CITY OF NAPOLEON - BUILDING DEPARTMENT 255 West Riverview Avenue, Napoleon, Ohio 43545 - 419-592-4010

Engineering Department		No. 862-77
P.O. Box 151 - 255 W. Riverview Ave. Napoleon, Ohio 43545		Date 12-1-77
CERTIFICATE OF	☐ Structural Plan Ap ☐ Electrical Plan Ap ☐ Special Plan App	proval
Outputted		
Submitted aut H. Shartzer By: 560 Euclid Avenue	☐ Architect	□ New
Napoleon, Ohio 43545	☐ Engineer ☐ Other	Addition Alteration
	E omer	☐ Mixed Occupancy
		☐ Change of Occupancy
NAME AND LOCATION OF JOB	OWN	ER'S AGENT
Adam's Barber Shop 510 Applan Napoleon, Ohio 43545	Paul H. Shar	tzer
	an IV. Codlesson	
TYPE OF CONSTRUCTION (Where Applicable)	pe IV Ordinary Const	ruction
O.B.C. Type of OccupancySto	ories	Basement
inspections shall be called for by the builder 48 hours in advan		
building can be used or occupied. THIS CERTIFICATE SHA		
UNTIL COMPLETION OF JOB. APPROVED PLANS MUST CONSTRUCTION.	BE KEPT ON JUB SITE	AT ALL TIMES DURING
	Plans, specifications and	or application as described above

ADDENDUM TO PERMIT APPROVAL ADAM'S BARBER SHOP PERMIT NO.862-77

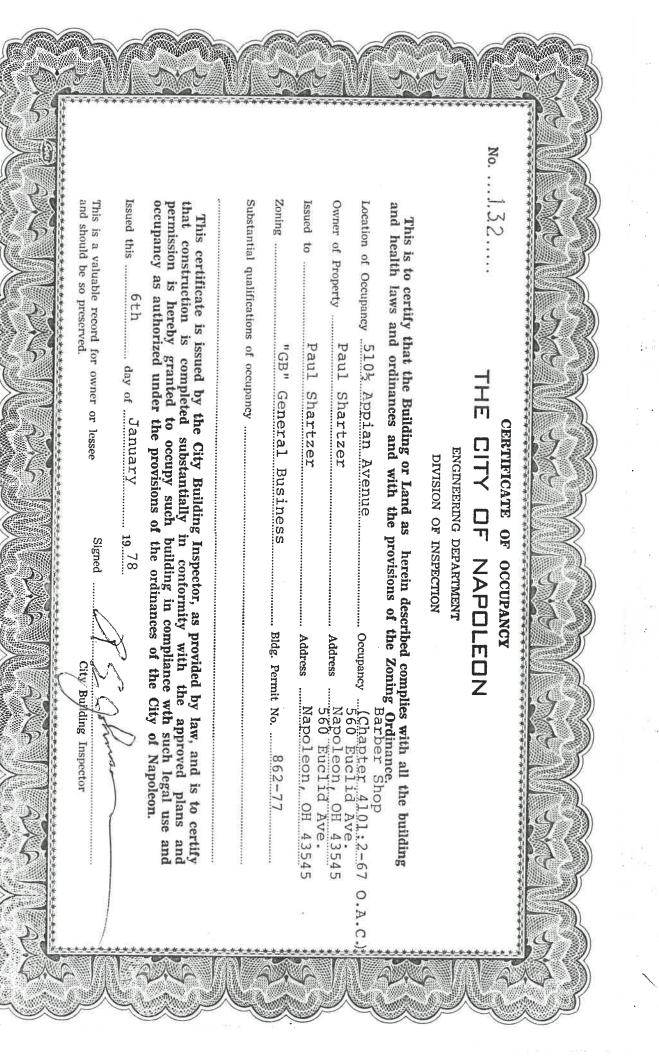
- 1. The ceiling height shall be at least 8'-0" in accordance with Section 4101:2-27-13 of the Ohio Administrative Code (OAC).
- 2. The window and door openings to be closed shall have a 1-hour fire-resistance rating in accordance with Section 4101:2-67-09 (B-1 and 2) of the OAC.

- 3. The interior partition separating tenants shall have a 3/4-hour fire-resistance rating in accordance with Section 4101:2-17-02(7) of the OAC.
- 4. The toilet room shall be made readily accessible to the public so the door shall open into the waiting area in accordance with Section 4101:2-67-23 (D) of the OAC.

- 5. A ventilating fan shall be provided in the toilet room in accordance with Section 4101:2-47-23(A) of the OAC.
- 6. Interior finish and trim shall be Class D in accordance with Section 4101:2-67-30 of the OAC.

- 7. NOTE: Fire separation of not less than 3 feet in accordance with Section 4101:2-67-05 of the OAC can not be obtained so openings on the east side of this building will not be permitted.

- 8. Fire extinguishing equipment shall be installed in accordance with Section 4101:2-67-32 of the OAC.
